Access Compliance Report

Public Rights-of-Way

(Curb Ramps)

Intersection ID: 9830	Main Street: ETHEL_GUEST_LN	Cross Street: GERALDINE_POWE_DR	Location: NW
ADA ID: EC8949720AE3	Ramp Type: PerpDiag	Initial Pass/Fail: Fail	Overall Compliance: No
Codes/Mitigation Info/Possible Solution		Field Measurements/Component Compliance	
Severity Score: 17.5

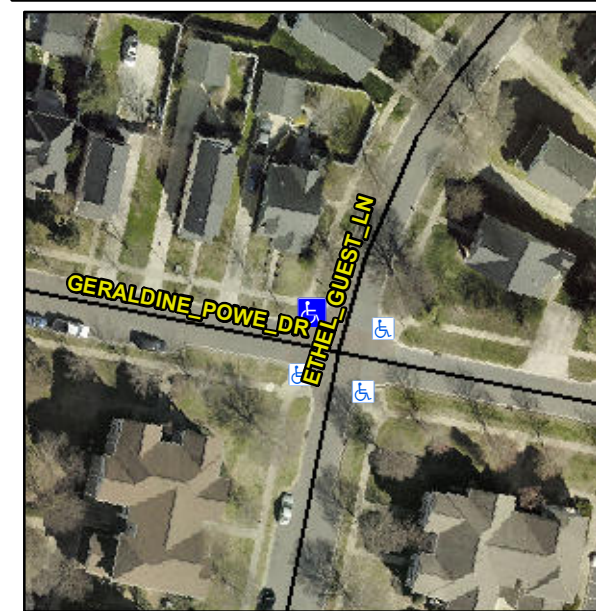
Not Found, R304.5.1

Compliance	Description	Data	Compliance	Description	Data
N/A	Ramp Length (in)	97.0	Yes	Ramp Slope (%)	6.2
No	Ramp Width (in)	32.5	Yes	Ramp XSlope (%)	0.9
N/A	Flare Type LT	N/A	N/A	Flare Type RT	N/A
N/A	Flare Slope LT (%)	N/A	N/A	Flare Slope RT (%)	N/A
N/A	Flare Traversable LT?	N/A	N/A	Flare Traversable RT?	N/A
N/A	Landing Length (in)	N/A	N/A	DWS Provided?	N/A
N/A	Landing Width (in)	N/A	N/A	DWS Contrast?	N/A
N/A	Landing Slope (%)	N/A	N/A	DWS Length (in)	N/A
N/A	Landing X Slope (%)	N/A	N/A	DWS Full Width?	N/A
N/A	Landing Curb? (Y/N)	N/A	N/A	DWS Offset (in)	N/A
N/A	Shared Landing?	N/A			
N/A	Gutter Ponding?	Yes	N/A	Gutter Slope (%)	N/A
N/A	Gutter Lip Ht (in)	0.5	N/A	Gutter X Slope (%)	N/A
N/A	Painted X Walk1?	No	N/A	Painted X Walk2?	No
	X Walk 1 Direction	To SW		X Walk 2 Direction	To SE
N/A	X Walk 1 Width (in)	N/A	N/A	X Walk 2 Width (in)	N/A
	X Walk 1 Slope (%)	3.9		X Walk 2 Slope (%)	2.3
	X Walk 1 X Slope (%)	1.1		X Walk 2 X Slope (%)	2.4

Remove & Replace Curb Ramp With Two New Directional Ramps or Equivalent.
